Re: SAJ-2004-12518 (SP-JCM)  
St. John Marina Yacht Club

Please accept this letter as The Summer's End Group, LLC's response to the Corps request for additional information by letter dated October 26, 2017 regarding the above referenced application. The applicant's response is as follows:

Shoreline Mangroves in Coral Bay. Note Water Quality

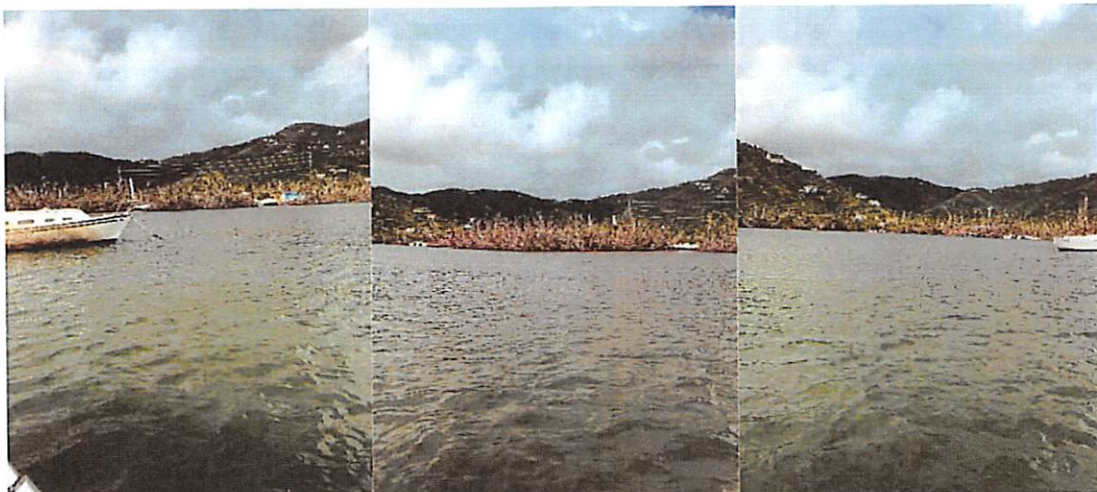
At least nine attempts have been made to resurvey the project area to determine the extent of seagrass and benthic impacts since early November without success. The project area still has very poor visibility due to suspended solids and turbidity in the waters resulting both from the effects of the hurricanes and the substantial amount of rainfall that has occurred since the hurricanes. As the island has had much of its vegetation destroyed, there is very little ground cover to keep soils and debris from washing into the harbor. Effectively, visibility is non-existent.

As of December 7, 2017, visibility is still too poor to conduct the detailed benthic survey which would be necessary to determine changes in seagrass coverage and potential for recovery. Based on touch, we know that seagrass is still present in some areas, but the extent of coverage could not be determined. It is probable that seagrass will recover consistent with past experience when vessels relocate, and the area is allowed to recolonize under favorable conditions.
